**ADDENDUM NO. 1**

PROJECT: **WASHINGTON COUNTY PUBLIC SAFETY TRAINING CENTER,  
PHASE-1 SITE DEVELOPMENT  
CONTRACT NO. MS-TC-266-28**

**ADDENDUM NO. 1**

**Washington County Contract No. MS-TC-266-28**

SITE PLAN - ELECTRICAL		PROJECT 3089	
PLOT SCALE: As Indicated		E0.5	
FILENAME:		DATE: July 15, 2019

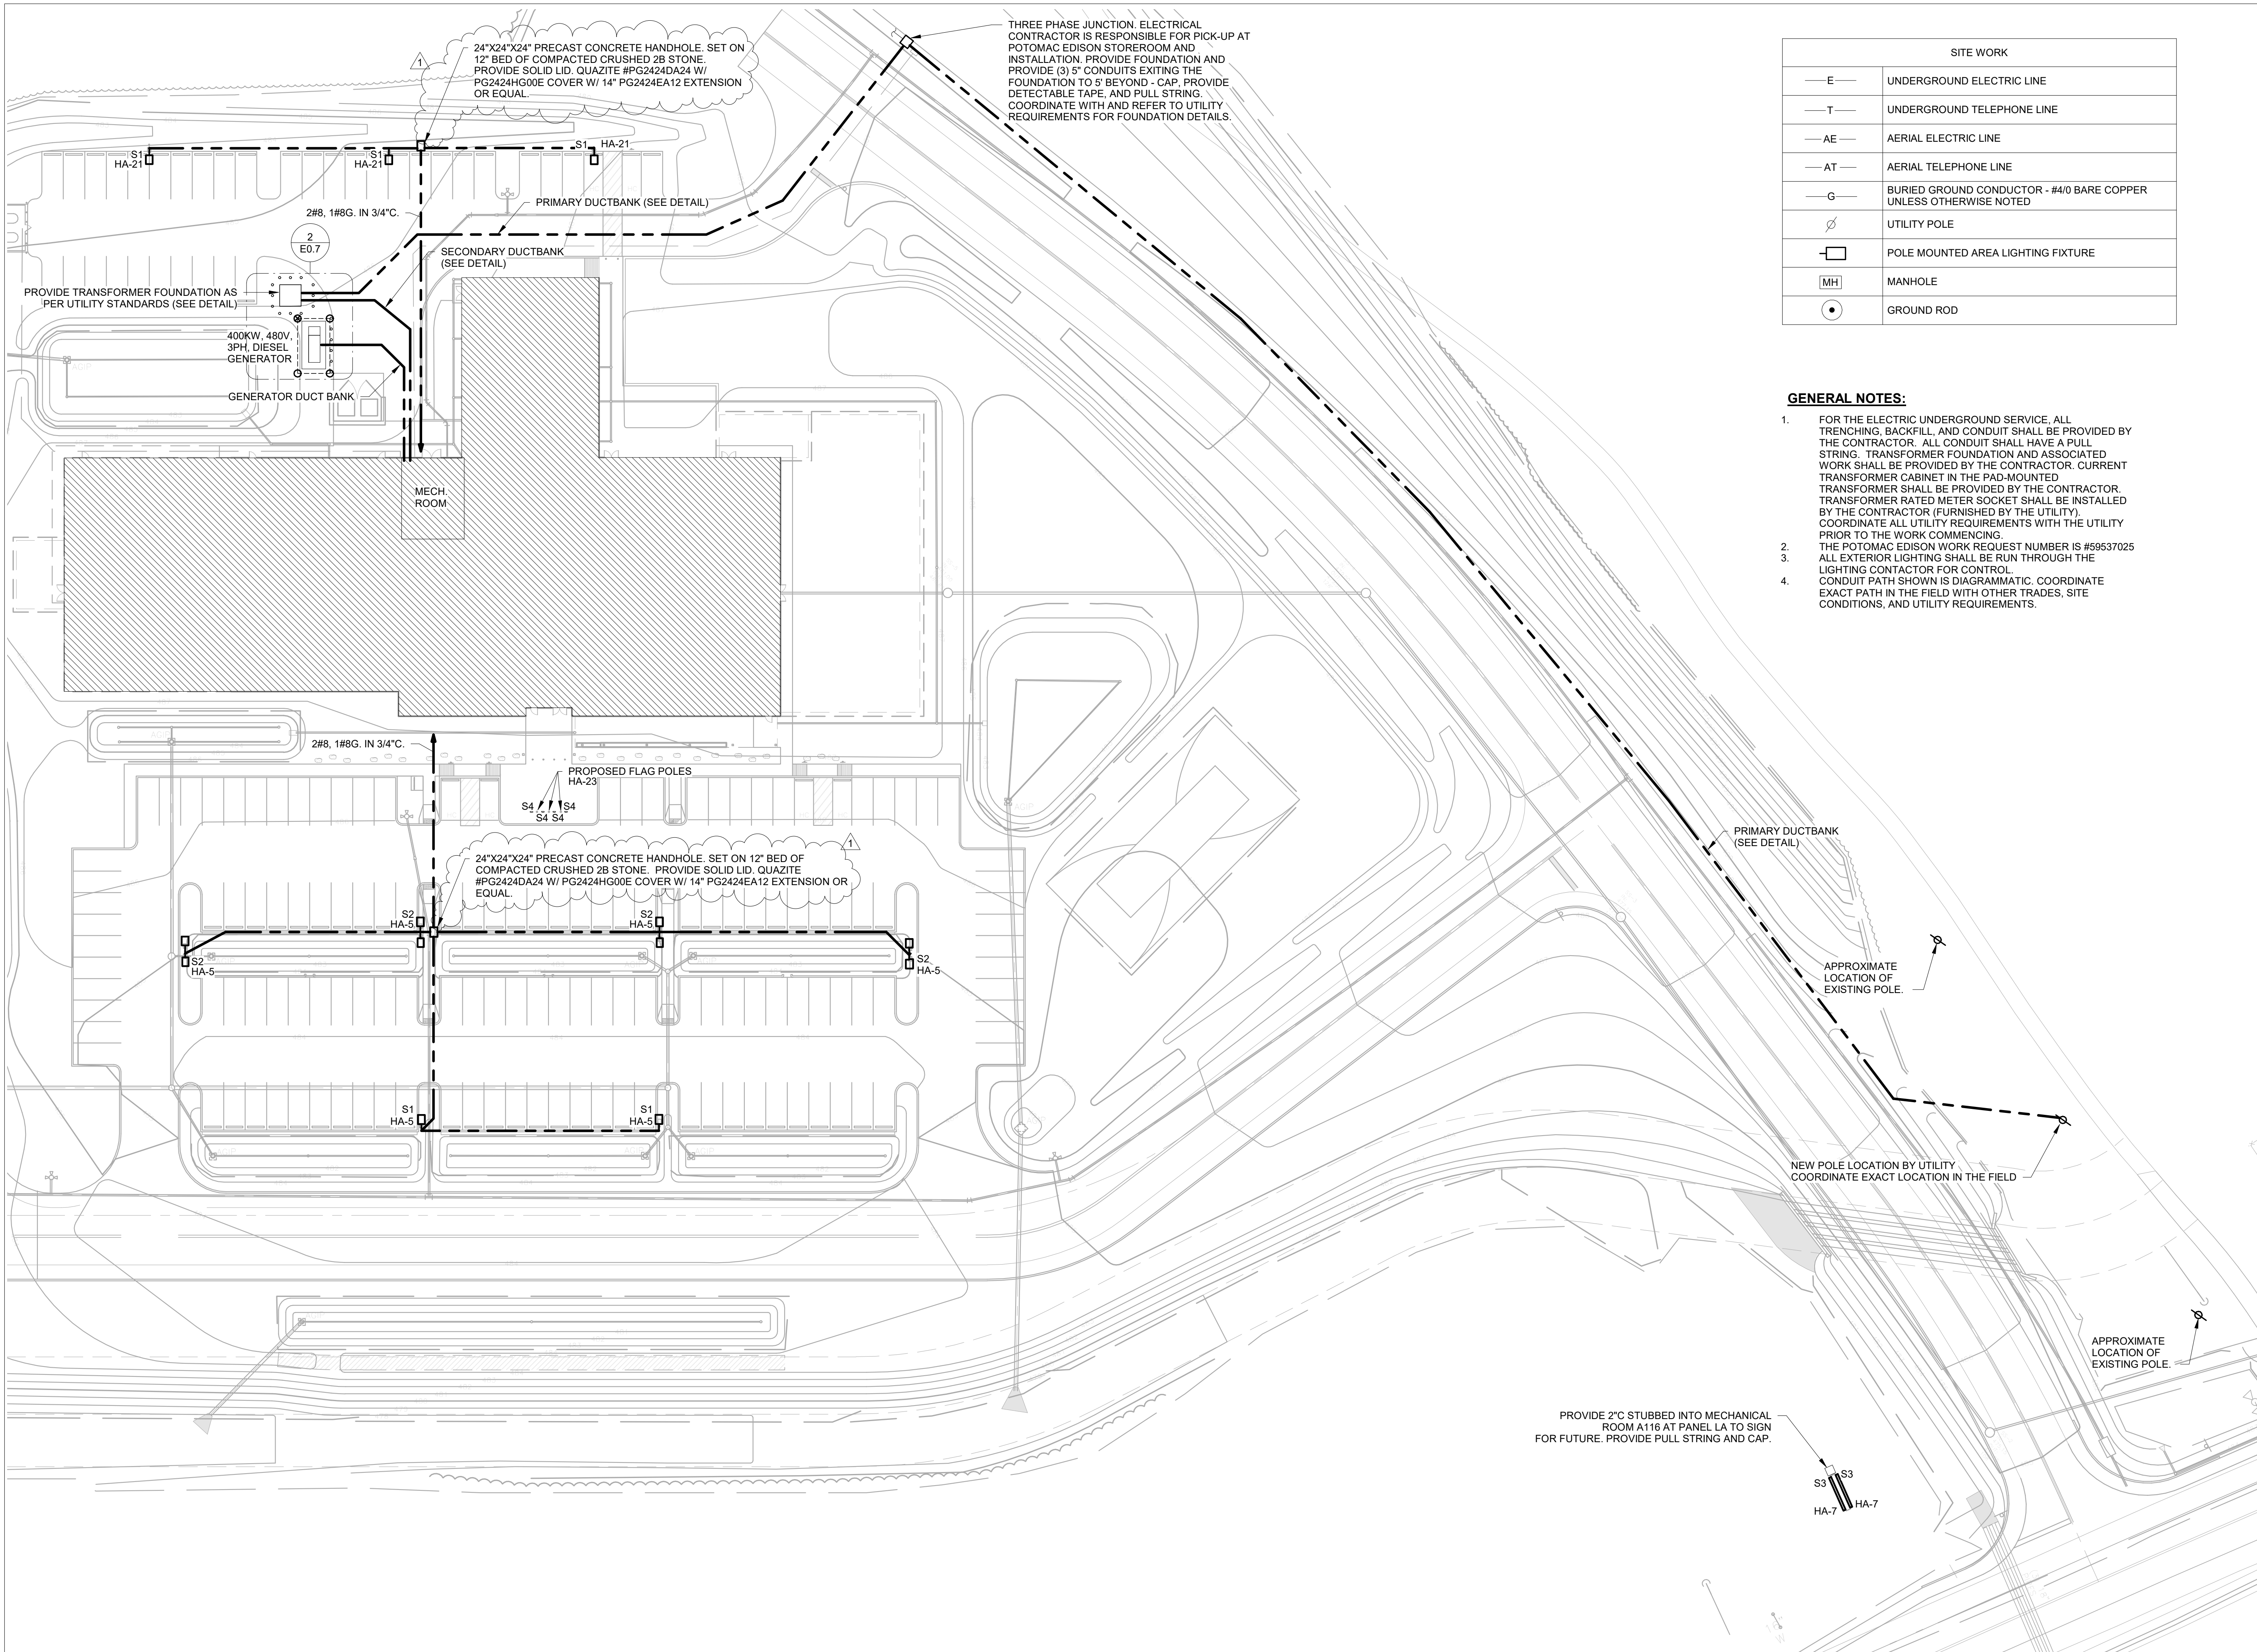
**Drawing No. "E0.5"**

**Revised Drawing No. "E0.5"  
(consisting of 1 page)**

NO.	MM-DD-YY	NAME	DESCRIPTION OF CHANGES
1	08/29/19	BIA	Site Revision

# NYLOPLAST DRAIN BASIN WITH SOLID COVER

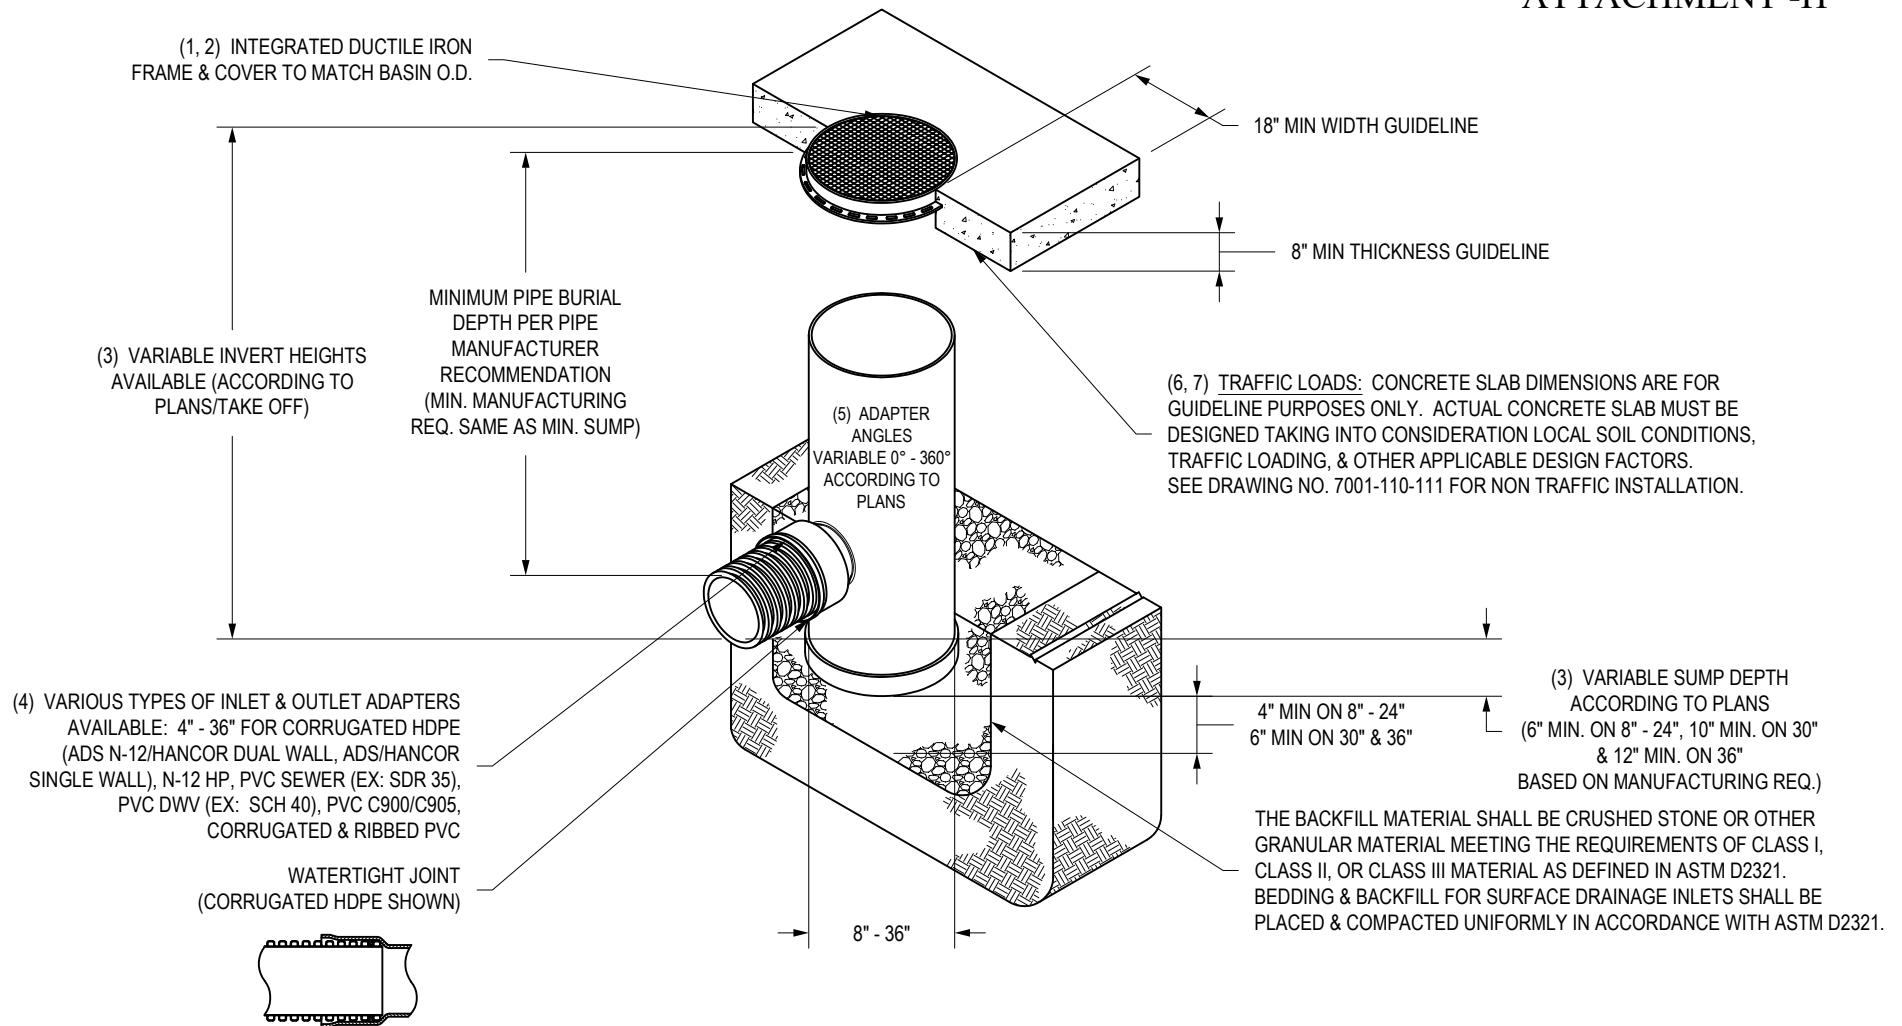
**ITEM 1.08** **ADDITION TO THE PROJECT DETAIL SECTION:**

**Nyloplast Drain Basin Detail with  
Solid Cover**
